UNITED STATES PATENT AND TRADEMARK OFFICE

APPLICATION NO.	FILING DATE	FIRST NAMED INVENTOR	ATTORNEY DOCKET NO.	CONFIRMATION NO.
10/721,834	11/24/2003	Andrew E. Neubauer	KCX-668 (19385)	4749
22827	7590	02/15/2006	EXAMINER	
DORITY & MANNING, P.A. POST OFFICE BOX 1449 GREENVILLE, SC 29602-1449			GIBSON, KESHIA L	
			ART UNIT	PAPER NUMBER
			3761

Office Action Summary

DETAILED ACTION

Fig. A: Examiner's mark-up of Merek's Fig. 6.

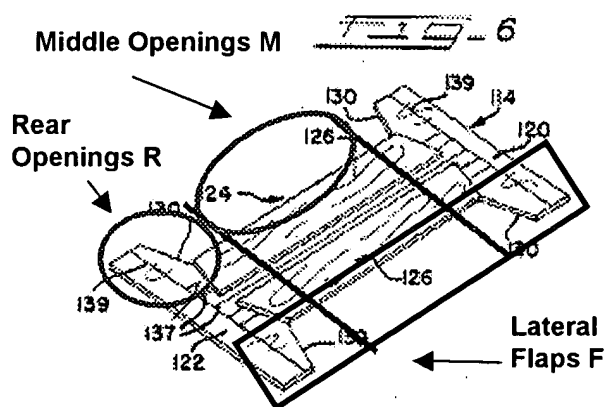
Applicant has argued that Mesek does not teach any openings in the absorbent structure and also does not disclose at least one rear opening. However, an "opening" is "a gap," "an empty space in or between two things," or "a vacant or unobstructed man-made space" (also see attached definitions). The middle opening previously identified by the Examiner is a gap that exists between edges 130 of the panel which are created when the absorbent structure 114 is cut to form flaps, which are folded over the center portion of the structure. As such, the areas M previously defined by the Examiner are still considered to be openings. Furthermore, based on application's disclosure, Mesek's openings are analogous to Applicant's openings, which are present on the outer edges of the absorbent structure. Additionally, the Examiner has determined "middle opening" and "rear opening" to related to the location of the opening within the absorbent structure. Thus the "middle opening" has been considered to be a portion of an opening extending within the middle region of the article and a "rear opening" has been considered to be a portion of an opening extending within the rear portion of the absorbent structure. As such, Examiner still considers the previously defined rear and middle openings to anticipate the invention as claimed.

In regard to Claim 1, Mesek discloses an absorbent article 10, 110 comprising an outer cover 16, 116, a liner 12, 112, and an absorbent structure 14, 114. The absorbent structure further comprises a front portion 22, 122, a middle portion 24, 124, a rear portion 20, 120, a pair of opposing lateral flaps F, a pair of opposing middle openings (marked M in Fig. A below) spaced between the middle portion and the (outer portions of) the lateral flaps F, and a least one rear opening (marked R in Fig. A below) (Figs. 2, 4-6; column 7, lines 5-47). The folded portions 26/126 of lateral flaps F have been folded onto at least the middle region 24, 124 (Figs. 2 and 6). The middle portion 24, 124 has a width narrower than the width of the front portion 22, 122 due to the location of the pair of opposing middle openings M (see Figs. 2, 4-6, Fig. A). The folded portions 26, 126 of the flaps F create a two-layer structure in the middle portion 24, 124 (Figs. 2, 4-6; column 7, lines 27-38).

In regard to Claim 2, Mesek discloses that the middle portion 24, 124 includes a plurality of thicknesses, or layers, to provide increased absorptive capacity to the crotch region (column 7, lines 27-31). As further depicted in Fig. 6, the folded portions 26, 126 result in the absorbent structure 14, 114 being two layers thick. In Fig. 4, the folded portion result in the absorbent structure 14, 114 being three layers thick. From Figs. 2 and 5-6, it can be seen that the front 22, 122 and rear portions of the absorbent structure 14, 114 are only one layer thick. Therefore, Mesek discloses that the folded portions 26/126 create a basis weight (analogous to thickness) in the location of the middle portion 24, 124 that is at least twice the basis weight of the areas of the rear portion 20, 120.

In regard to Claim 12, a basis weight in the middle portion 24, 124 that is at least 25% greater than that of the rear portion 20, 120 would mean that the structure 14, 114 is at least 1.25 times thicker in the middle portion 24, 124 than in the rear portion. As discussed for Claim 2, Fig. 6 shows that the folded portions 26, 126 of flaps F result in the absorbent structure 14, 114 being at least two layers thick in the middle portion 24, 124; and, the front 22, 122 portion of the absorbent structure 14, 114 is only one layer thick. Since two layers is 2 times thicker than one layer, the basis weight in the middle portion 24, 124 would be at least 25% greater than that of the rear portion 20, 120.
